Subject: **UMT0102261/CU-521**
Wildwood Club Proposed Dike between structures 103A7478 & 103A7477

RE: Wildwood Club Proposed Dike between Structures 103A7478 & 103A7477

**Project No: UMT0102261
CU-521**

PROFILE- DIKE #1

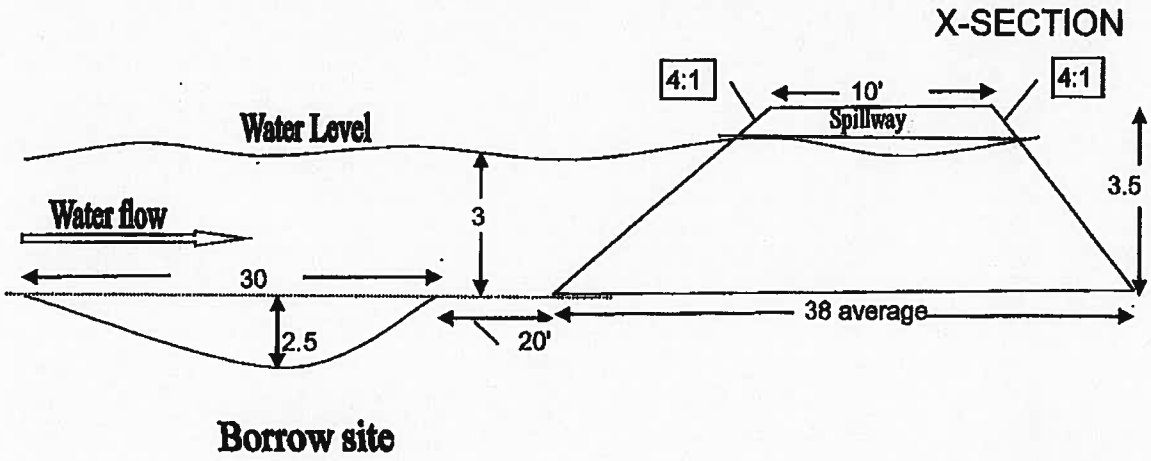
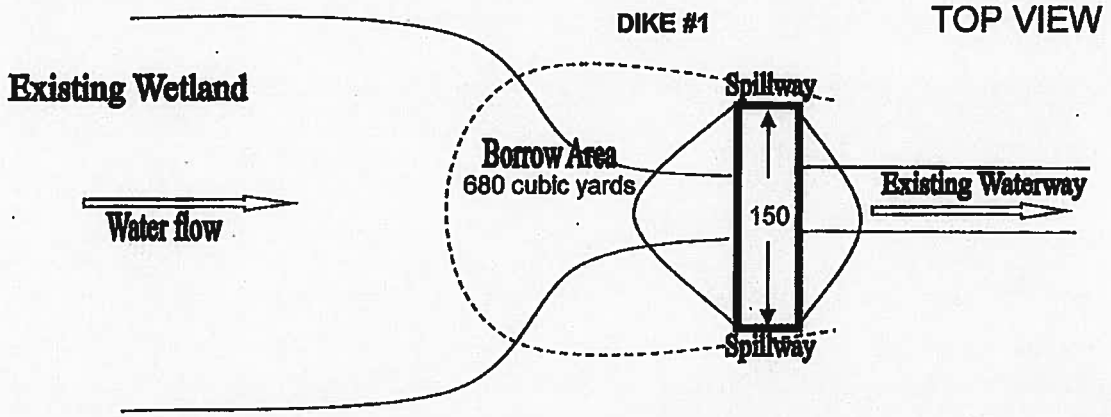
1. The top of the dike be no less than 14' in width to accommodate vehicular traffic.
2. ITC will not be responsible for any damage to the dike caused by ITC personnel or contractors accessing, maintaining or replacing the transmission poles or conductors.

The grade between the poles goes well below that in the rest of the area. Even the raising of the grade by the dike will not bring it up near to what it is at poles 7477 and 7478. The service road is not directly under the lines; in fact the area under the lines is where the material for the dike would be taken. The pond below the power lines would mean that no trees would be growing that could eventually interfere. The service road is not passable in this area because of washing out. We believe that the dike will be a definite benefit to Consumers by making the service road usable.

Our HVD dept is reviewing. Our initial response was changing the grade may very well impact thr required clearance spanning several poles, it is still under review.

The USFWS is happy to comply with the request to widen the top of the dike proposed for construction at the Wildwood Club property to 14 feet wide. We will acquire a revised permit from the State of Michigan once permission is granted from all entities, and we are ready to begin the construction phase of the project.
